Re.: DSP 21001, Suffrage Point South

Item: DSP 21001 – Magruder Pointe-Suffrage Point South

Requested Actions: -Deny Werrlein's Detailed Site Plan
-Provide Essential Transparency
-Uphold the Law and Protect the Credibility of the Planning Process

Figure 1 View of the Lower Lot, Driskell Park, Trumbule wetland, and surrounding neighborhood (within the blue circle), with number of hazards indicated by yellow to red map colors overlaying satellite imagery. Image created on January 23, 2023 from NOAA's Coastal Flood Exposure Mapper.

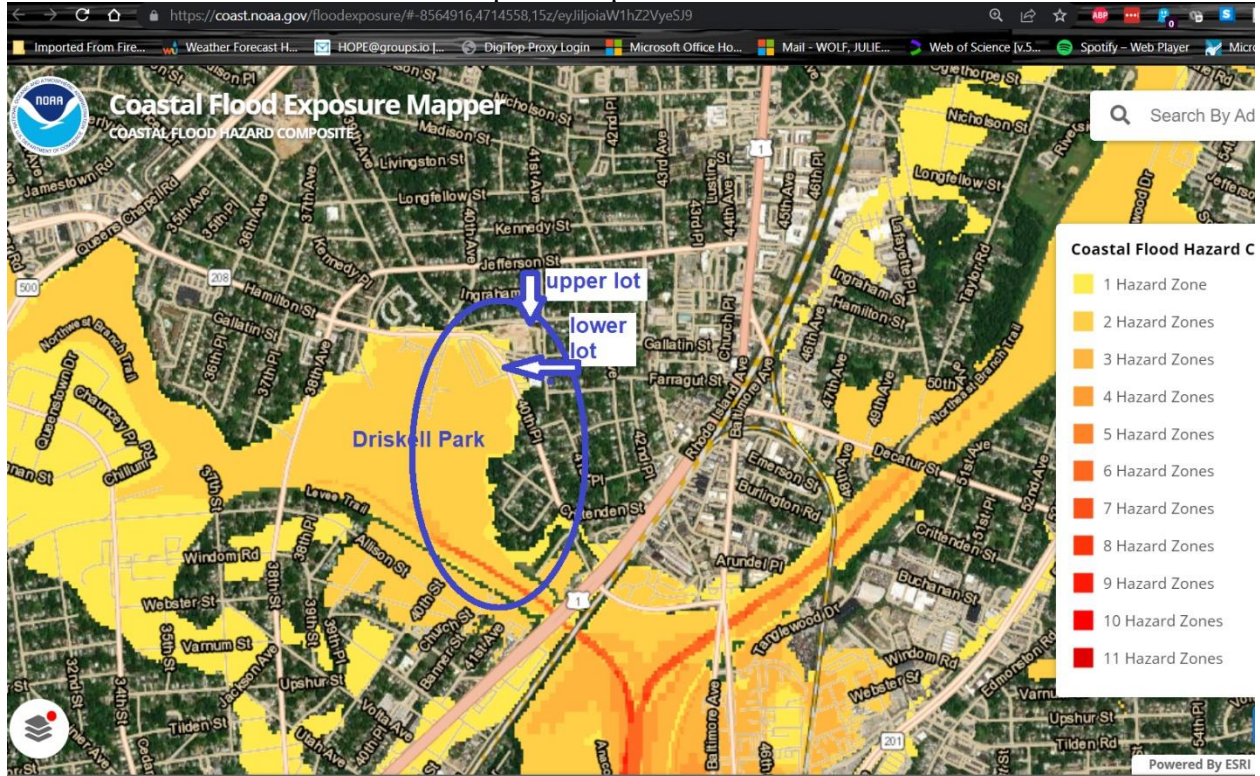
I oppose Werrlein's plan to build townhouses on the lower parcel. This land lies in the 100-year floodplain of the Northwest Branch and drains through areas of the park at risk of Storm Surge flooding, and therefore should not be developed. Global warming is bringing more severe storms, and the lower parcel sits adjacent to Hyattsville's most heavily used park, a forested wetland and stream valley, and a family's home.

For the sake of protecting public safety, resources, property, and the environment, the Planning Board must investigate whether Werrlein's plans and any related agency approvals account for recent and expected near-future climate change. The Planning Board should also consider that Werrlein apparently has operated on the site without required county, state and federal environmental permits and appears to have discharged sediment pollution into the Northwest Branch of the Anacostia River on numerous occasions.

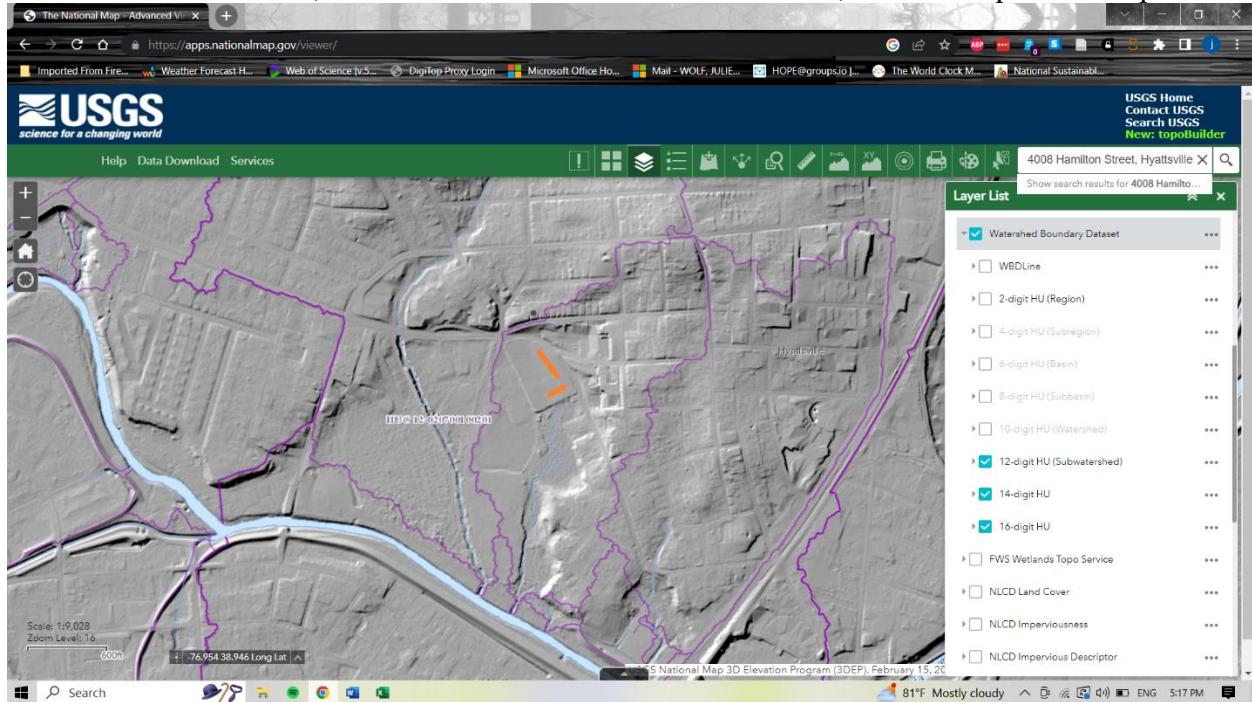
Werrlein has already elevated a large part of the lower lot by creating large berms of fill soil. These are roughly indicated in orange in the map below. The placement of the berms is such that surface stormwater flow is displaced to the same part of Gallatin Street that has repeatedly flooded; from there water must flow over and through Driskell Park to reach the river. These berms must be removed, and similar elevation cannot be allowed, in order to protect the park.

Because of these aspects of the site's watershed, I oppose any construction on the lower lot of the proposed Magruder Pointe-Suffrage Point South, and suggest that the berms created in the last few years must be removed and remediated. While I am not a hydrologist, I have sufficient knowledge of the impacts of climate change on the environment to feel confident in my interpretation of the NOAA and USGS maps, and in my conclusion that the lower lot is not suitable for this or any development. I do not believe that these aspects have been appropriately considered by the relevant County or State agencies.
